Urban Design Assessment

Amended additional commentary for Planning Proposal for Hornsby RSL Club sites at:

1A & 3-7 William Street & 2 Ashley Lane (Hornsby RSL Club & Community Car Park),
4 High Street (Hornsby RSL Club), and
7-19 Ashley Street & 2-4 Webb Avenue, Hornsby

Date: 20 December 2016

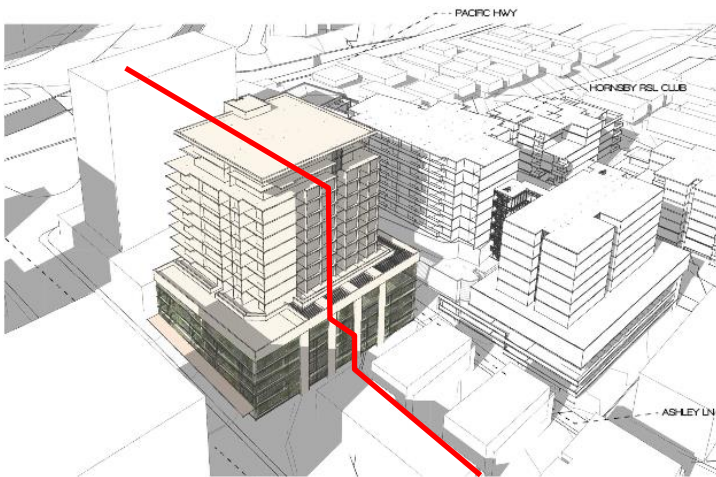
The applicant has provided a 3D view as per the request in GMU's previous commentary. The 3D view clearly shows that the proposal presents a rather abrupt relationship with the 4-storey development to the west and also presents an oversized bulk in context with the surrounding built form.

FORBES STREET ELEVATION

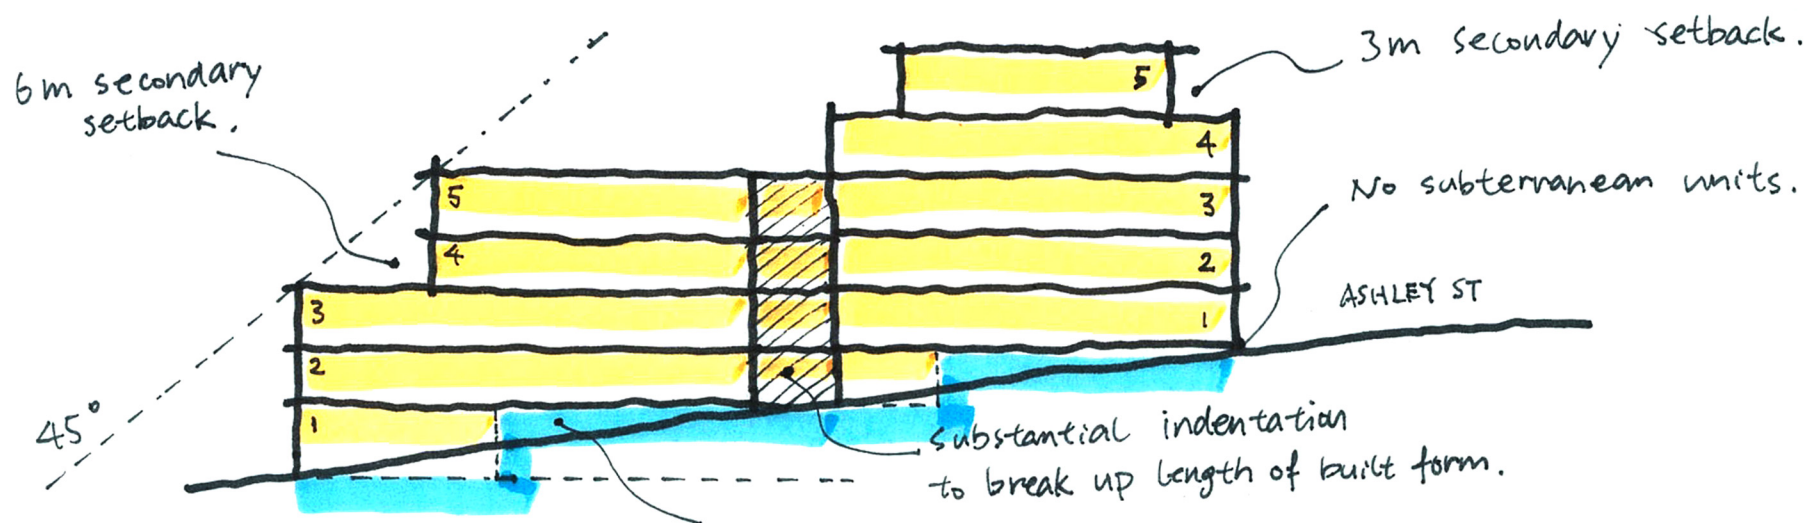
Protrusion of car park no more than 1m above ground. It is important for the built form to step with the topography to avoid exposed basement, subterranean units and to break the bulk and scale.

The upper levels above the street wall should be sufficiently setback to reduce their perceivable bulk from the street. GMU recommends that:

- a minimum of 3m secondary setback should be provided to Ashley Street and Forbes Street.
- a minimum of 6m secondary setback should be provided to Webb Avenue.
